IEEE802.3bt
LLDP adhoc

Meeting #5: Wednesday July 12, 2017
Revision 001

- **The purpose** of this ad-hoc is to resolve LLDP state machine related comments from D2.4 and related issues for PSE and PDs prior sponsor ballot for D3.0.

Annex A: Why we need $Y=A+B$ as currently in the spec? -2

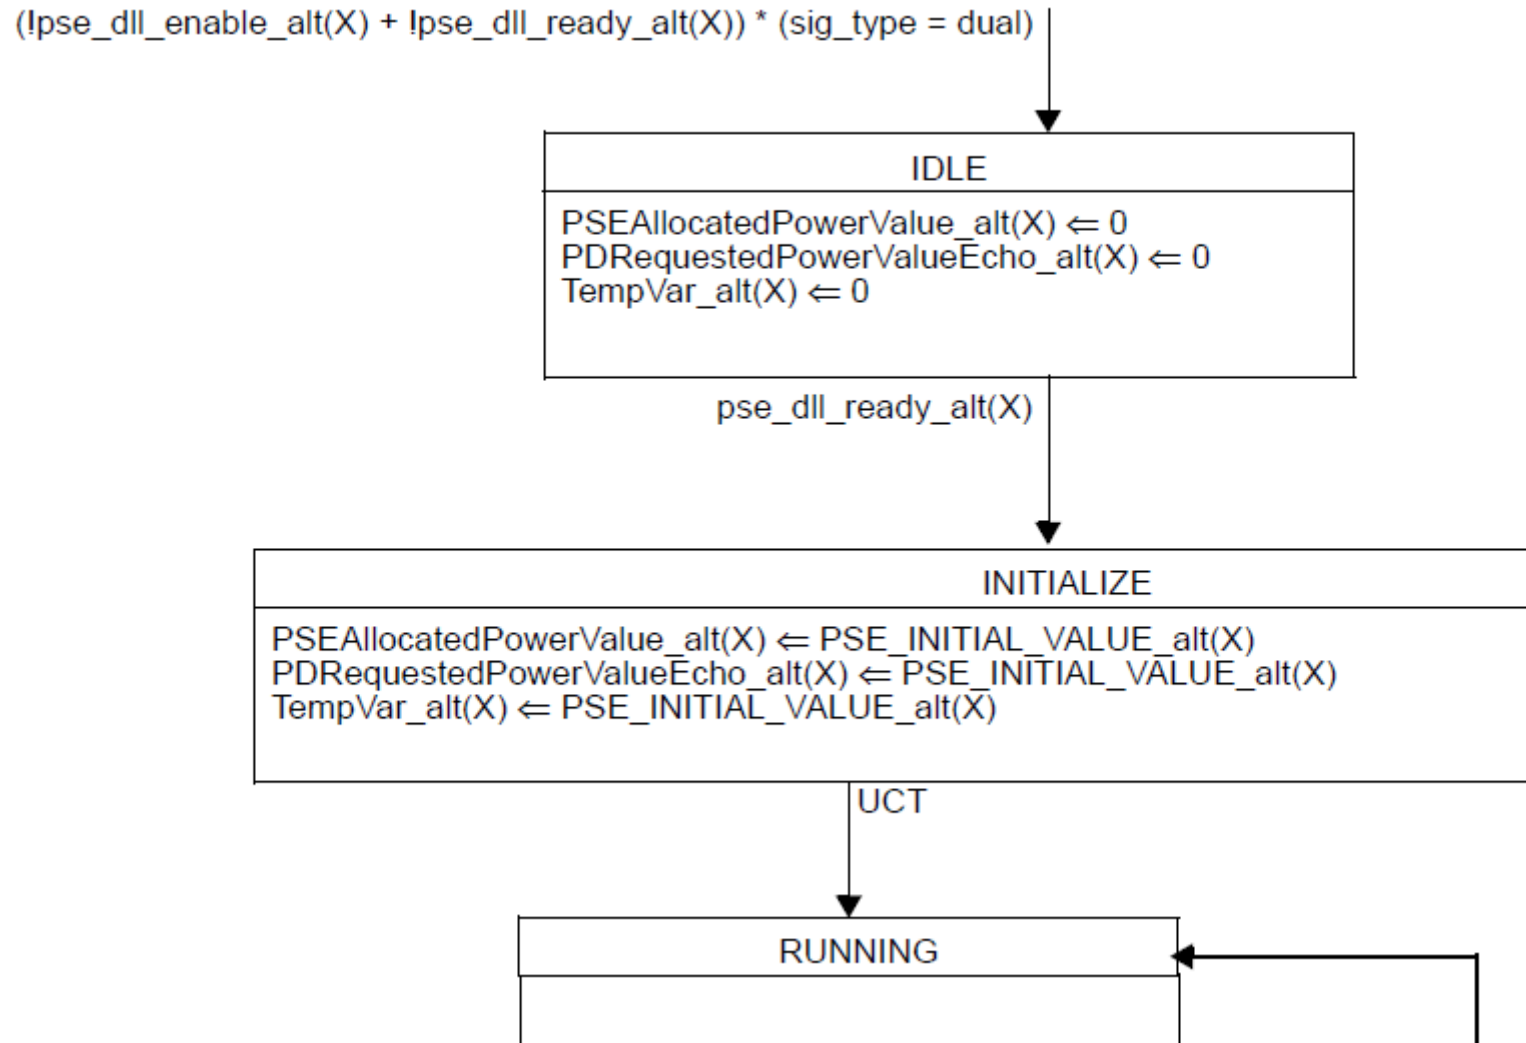
- Argument #3

High level power management care only for the total port power. The power management per pairset is kind of sublayer of the power management system. It is useful to pass the total power through the TLVs field. This is in general how current PSEs systems works.

Other alternative solution to this problem is to use the field “PSE max available power” which should be the total port power. We need to clarify in 79.3.2.6e that this value is applicable for PSE that supports single-signature and dual-signature.

Annex B: Comment #297 D2.4 (Page 75 line 12 in D2.5) - Figure 145-43

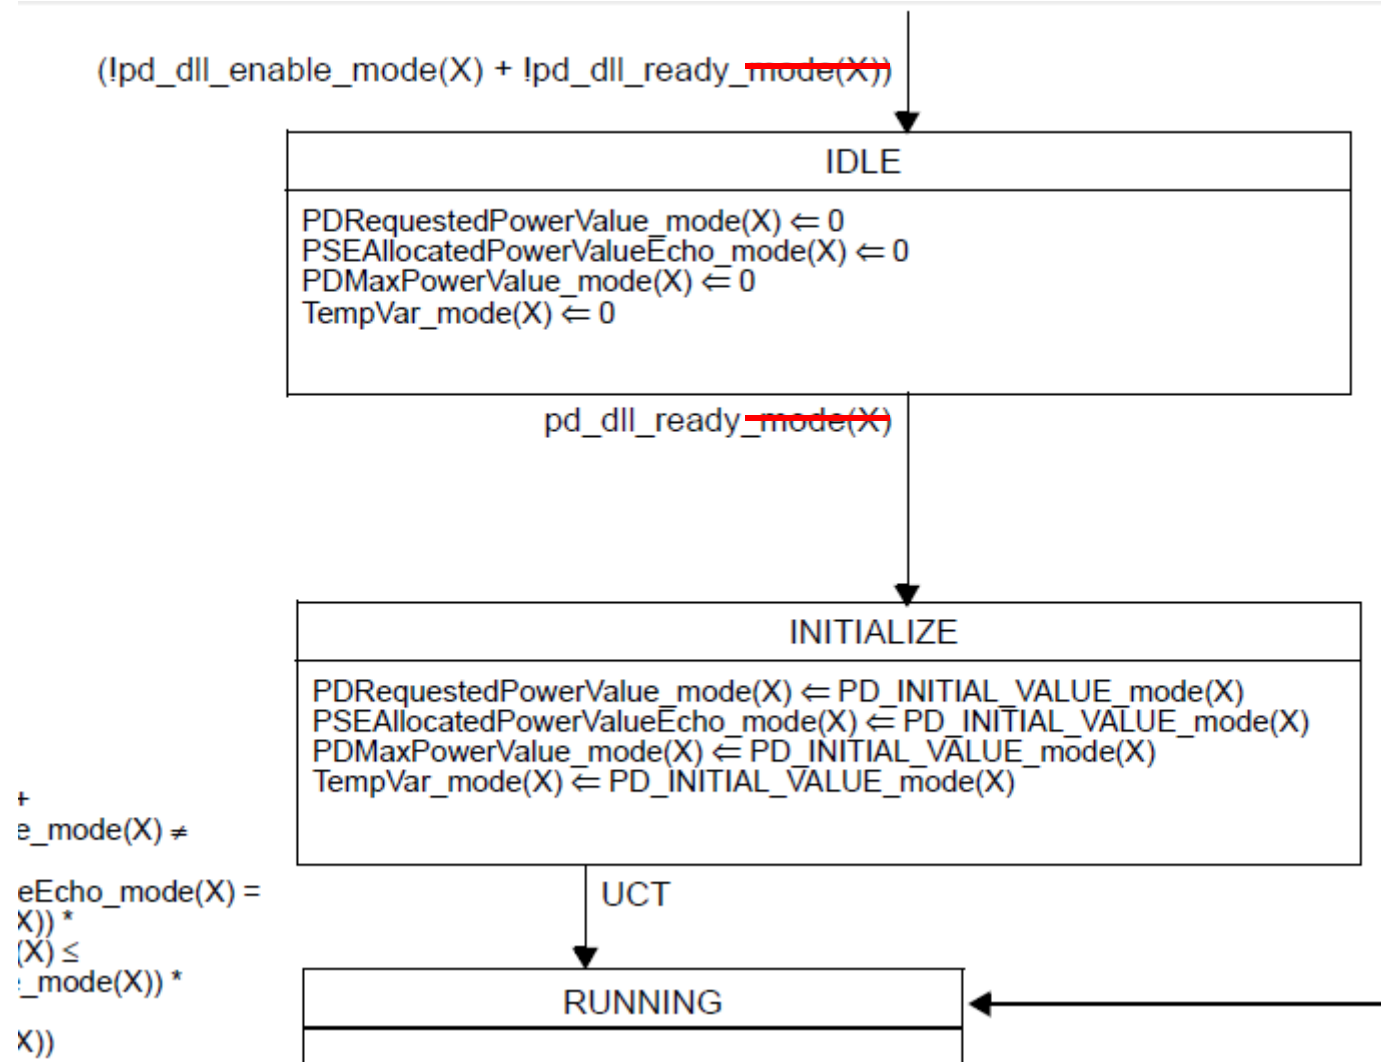
- Comment #297 D2.4 (D2.5 Page 78 line 46)

"If Mode (X) is non-active while the other mode is active, the inactive PD requested power value Mode (X) field value shall be set to 0."

- What is this trying to do ? The PD may wish to ask for power on an unpowered Mode...

Yair: What we are trying to do is:

- In Figure 145-44 and Figure 145-45 power control state diagrams when connected to dual-signature PD, we add in D2.3 an IDLE state in order to resolve non active Alternative(X) or no active mode(X) by setting the relevant variables to zero prior going to INITIALIZE state.
 - Figure 145-45: PSEAllocatedPowerValue_alt(X), PDRequestedPowerValueEcho_alt(X) and TempVar_alt(X)
 - Figure 145-46: PDRequestedPowerValue_mode(X), PSEAllocatedPowerValueEcho_mode(X), PDMaxPowerValue_mode(X) and TempVar_mode(X)

- We have the information of total available power in the field “PSE maximum available power” in 79.3.2.6e. This resolve argument #2 in Annex A.
- To resolve #297, Lennart suggests: In order to request power on the unpowered pairset, see proposed changes in the red text. In addition, the `pd_dll_ready_mode(X)` need to be changed to `pd_dll_ready` to allow progressing to the INITIALIZE state in case PD want power on the unpowered pairset. No changes required in the PSE portion.

- Yair it will work:
- The proposal is:
 - To change from `pd_dll_ready_mode(X)` to `pd_dll_ready` in the PD state machine.
 - To change “if this mode/Alt is inactive, set to value 0” to “if this Alt is inactive, set to value 0” i.e. keep this requirement only to PSE.

- Lennart response: The proposed response to this comment is to adopt:
 - To change from `pd_dll_ready_mode(X)` to `pd_dll_ready` in the PD state machine.
 - To change “if this mode/Alt is inactive, set to value 0” to “if this Alt is inactive, set to value 0” i.e. keep this requirement only to PSE.
- **Group to discuss.**
- **GROUP OPINION? Group is OK.**
 - The modifications proposed to the state machine in Figure 145-43?
 - To change from `pd_dll_ready_mode(X)` to `pd_dll_ready` in the PD state machine.
 - To change “if this mode/Alt is inactive, set to value 0” to “if this Alt is inactive, set to value 0” i.e. keep this requirement only to PSE.
